Addendum No. 2
March 20, 2026

Project: Union County Courthouse Addition and Renovation
Elk Point, South Dakota
Architecture Incorporated Project Number 0728.2893.20

Architect: Architecture Incorporated

1. DRAWING SHEET 4.01 – DEMOLITION FLOOR PLAN

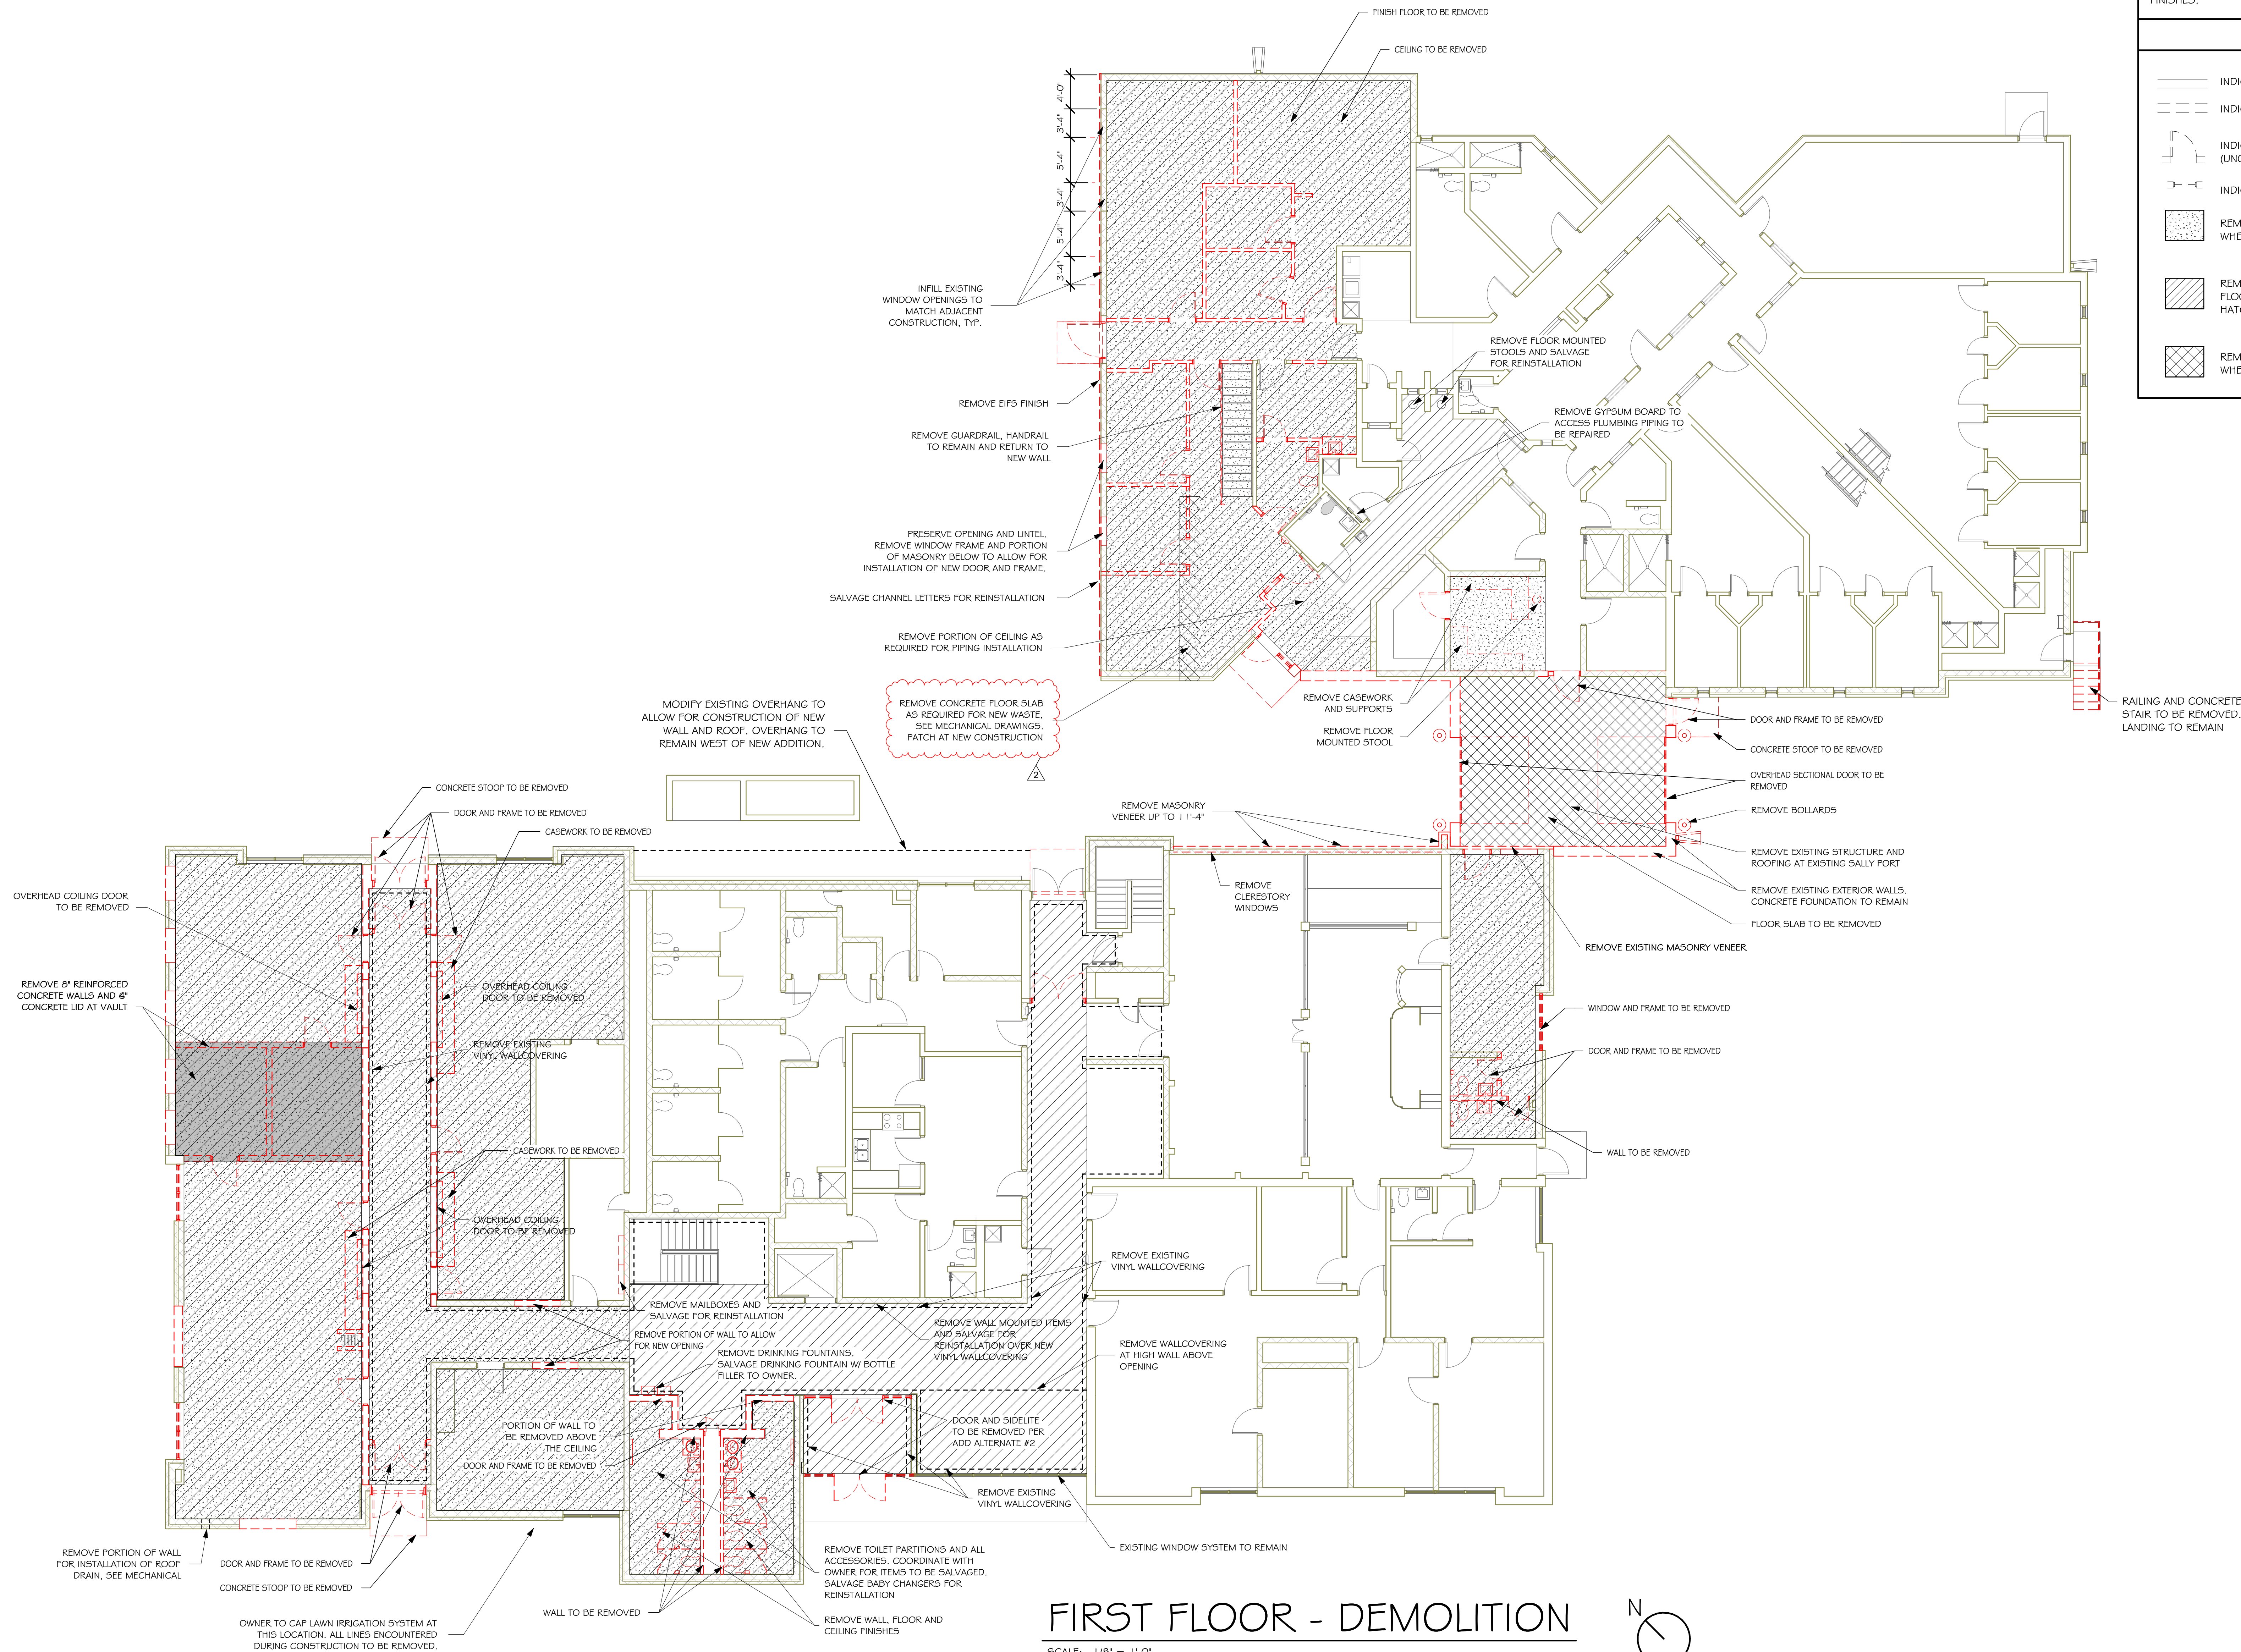
- a. See attached revised Drawing Sheet 4.01 at area B, indicating floor sawcut to allow install of new sanitary sewer.
2. DRAWING SHEET 4.11 – FIRST FLOOR PLAN – AREA A

FIRST FLOOR PLAN - AREA A

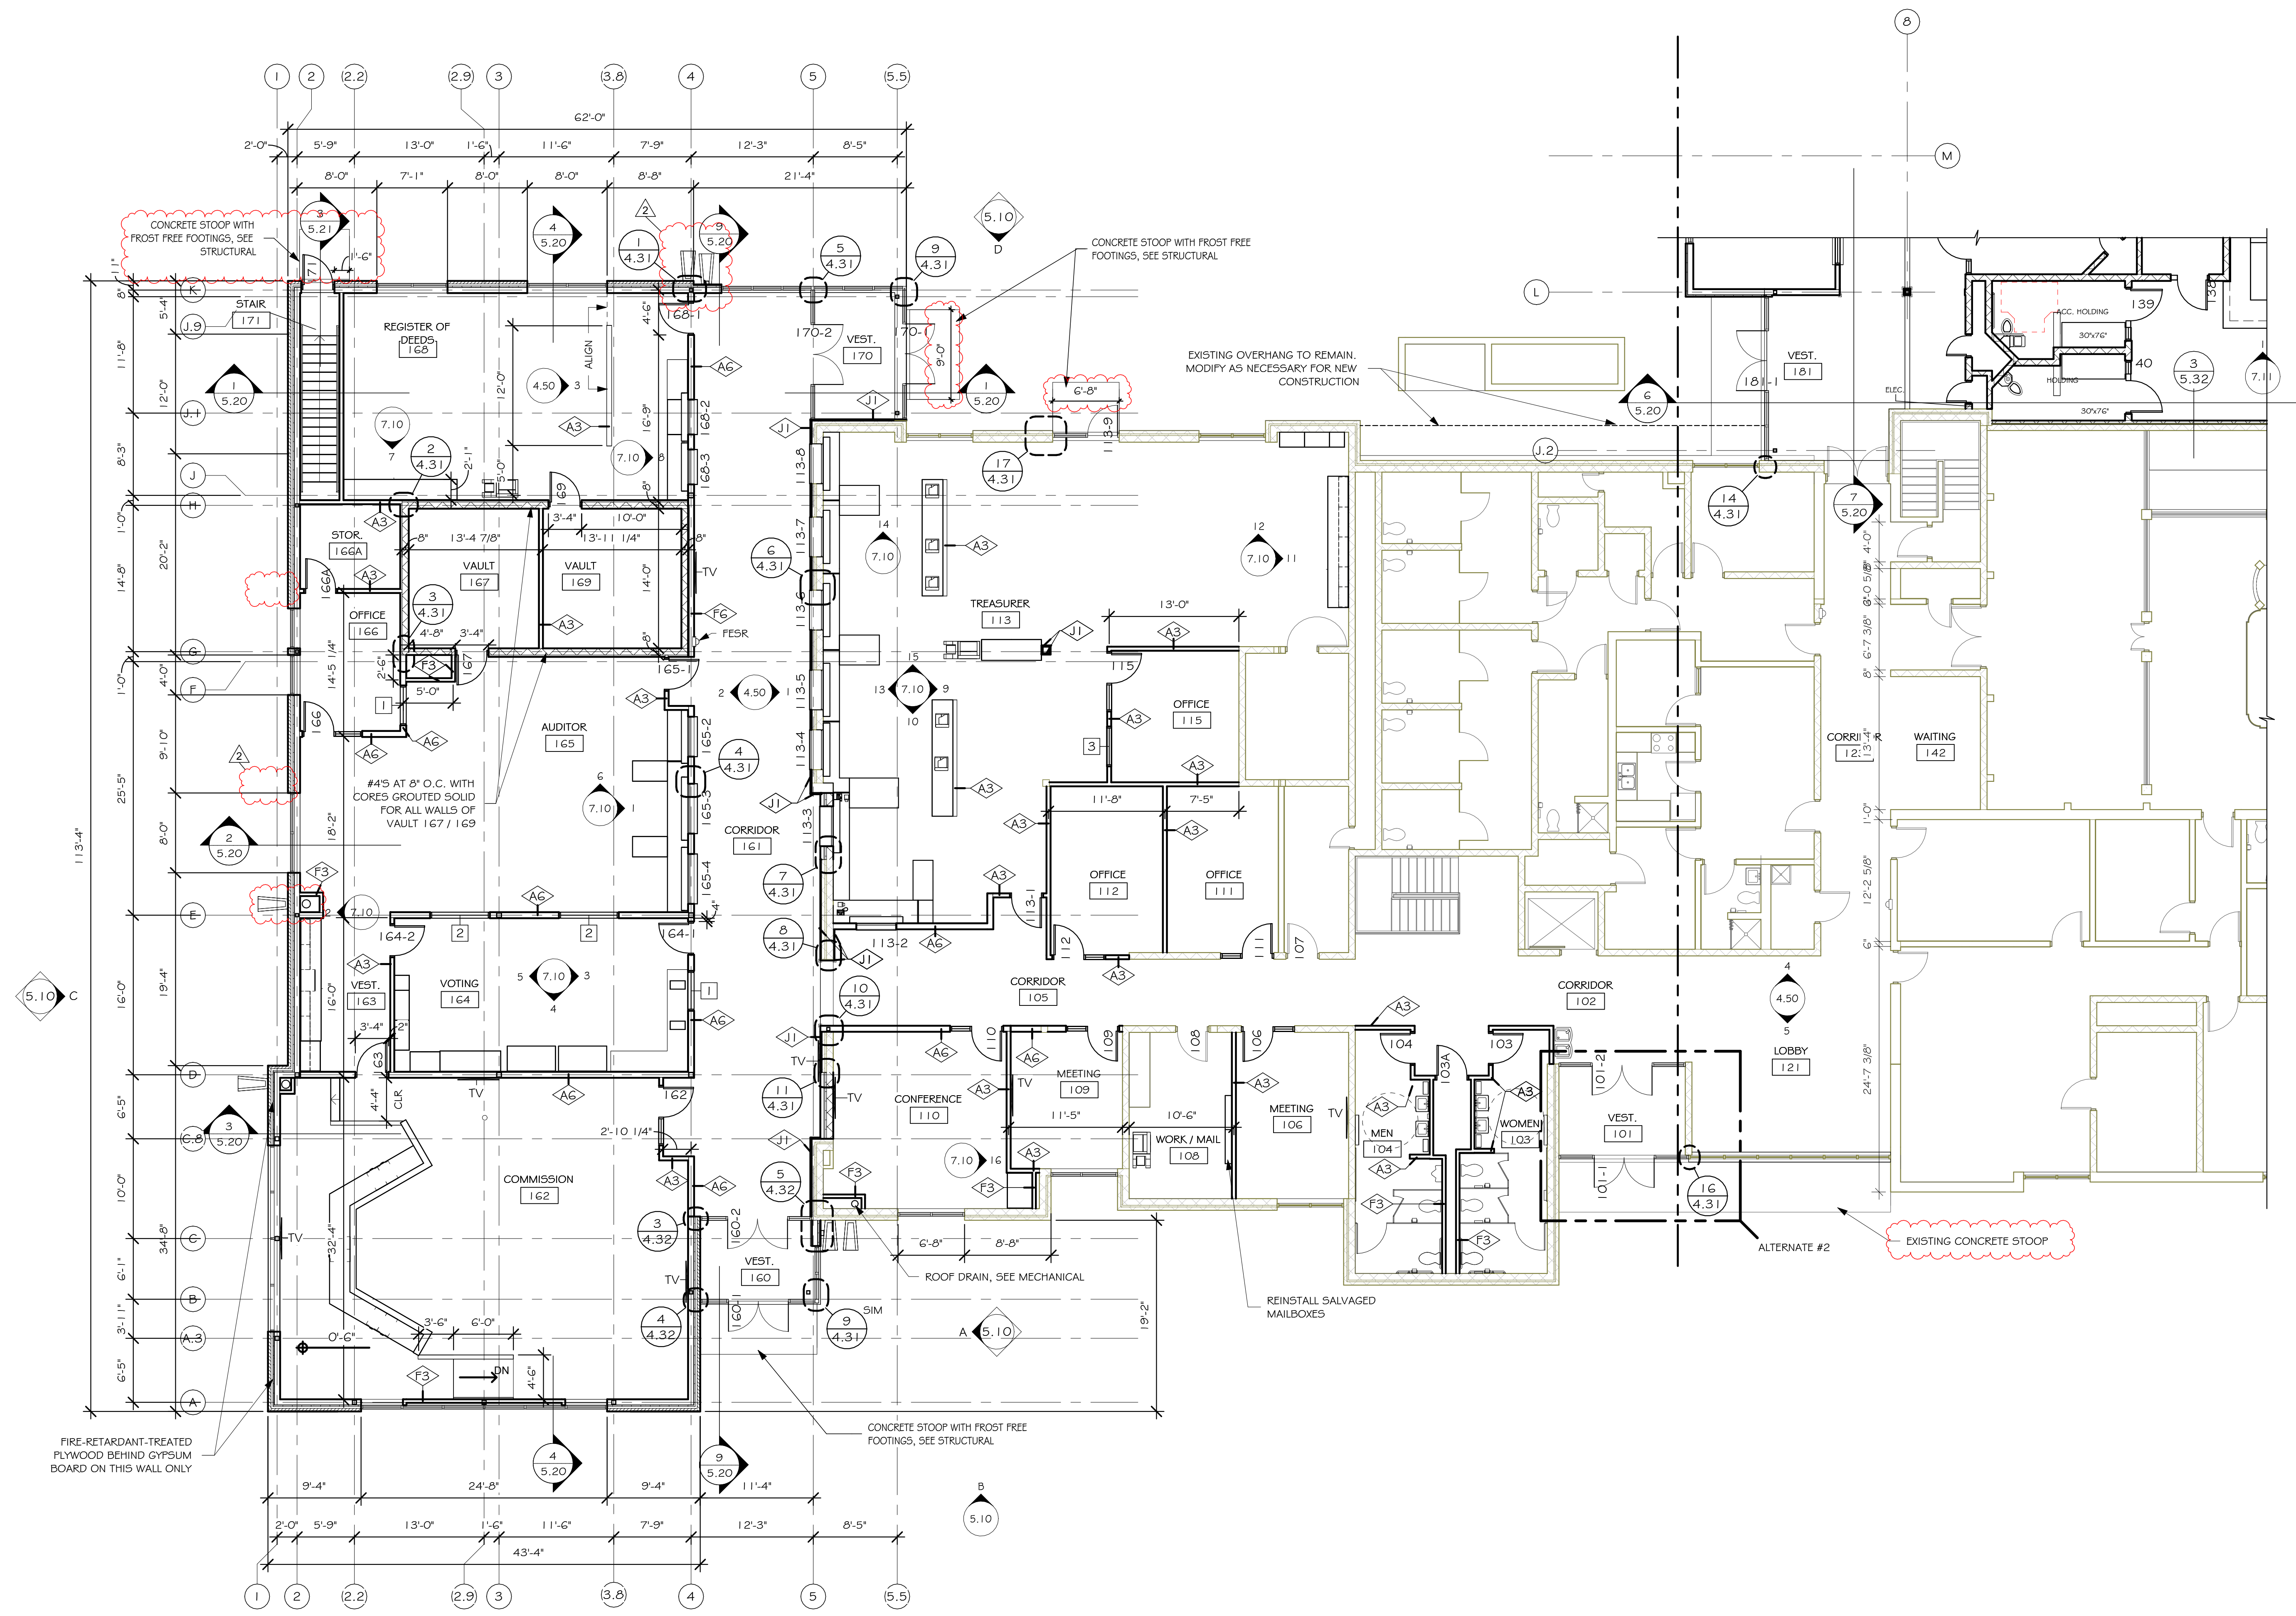
- a. See attached revised Drawing Sheet 4.11 for:
 - i. Revised concrete stoop locations and dimensions.
 - ii. Clarified splash block location respective of roof drain types.

FIRST FLOOR PLAN - AREA B

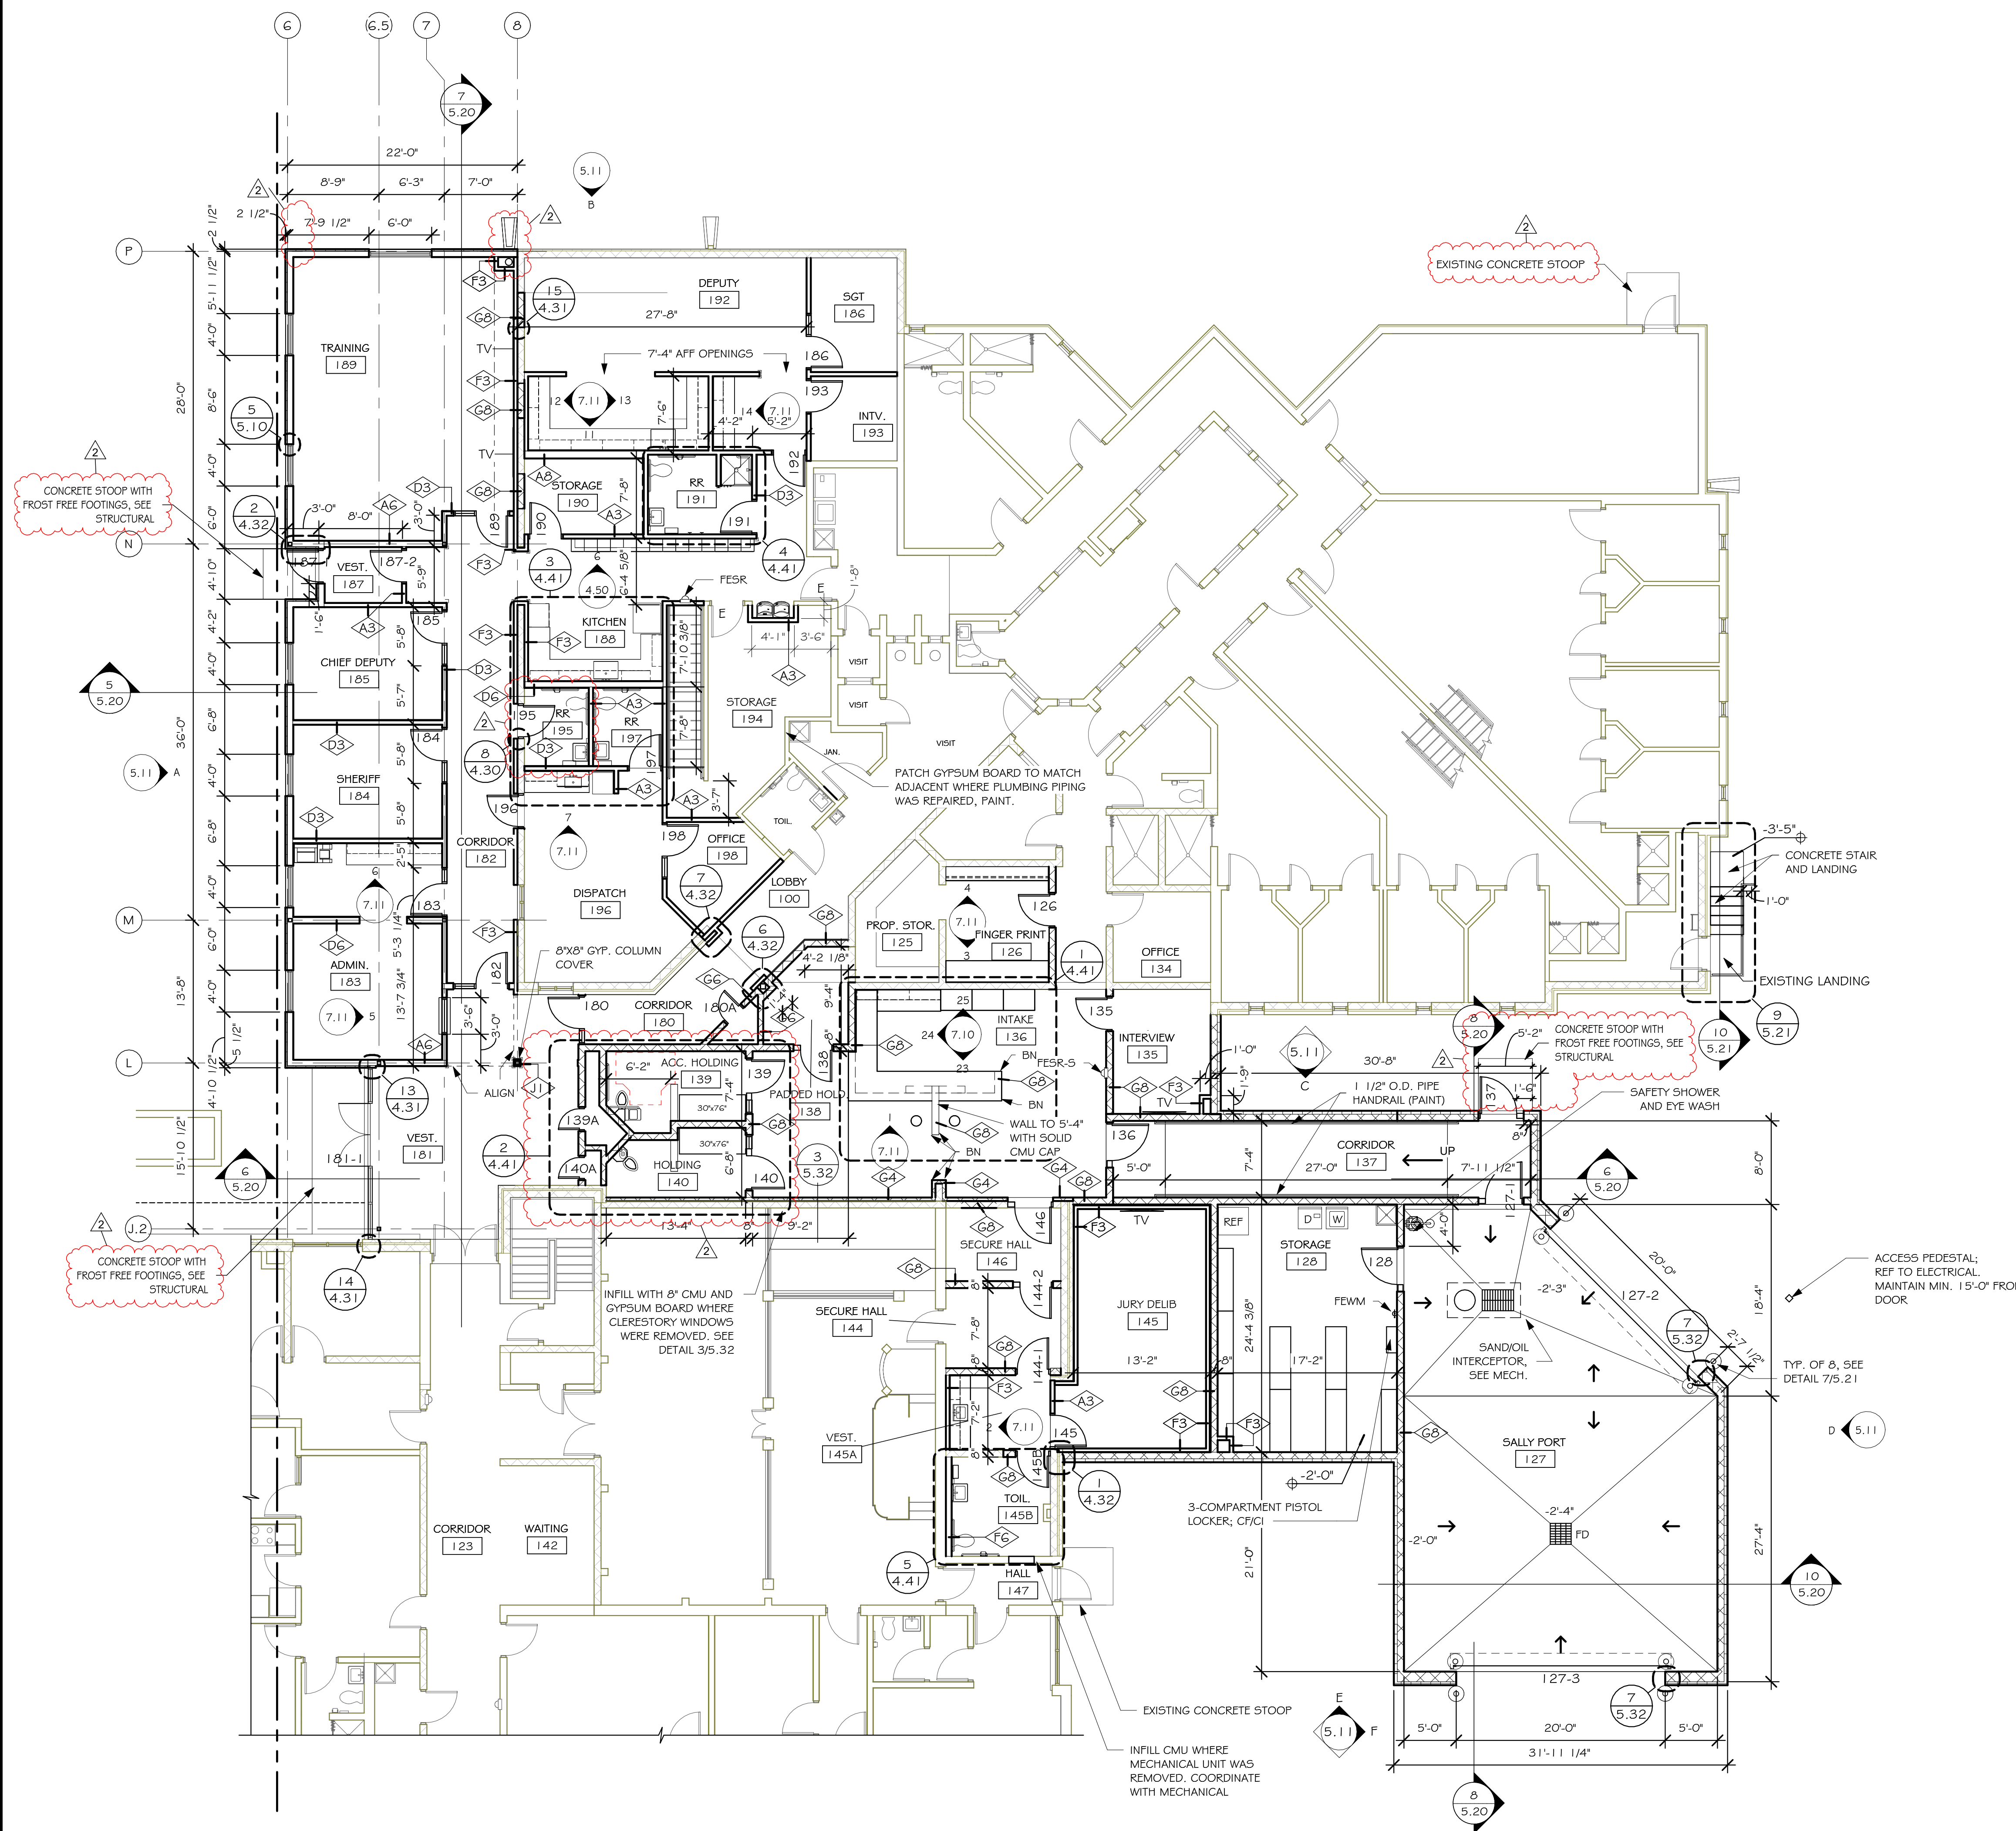
3. DRAWING SHEET 4.12 – FIRST FLOOR PLAN – AREA B
 - a. See attached revised Drawing Sheet 4.12 for modifications to the layout of Holding 139 and Holding 140.

- b. See attached revised Drawing Sheet 4.12 revised concrete stoop locations and dimensions.
4. DRAWING SHEET 4.30 – DOOR SCHEDULE/DETAILS/BORROWED LITES
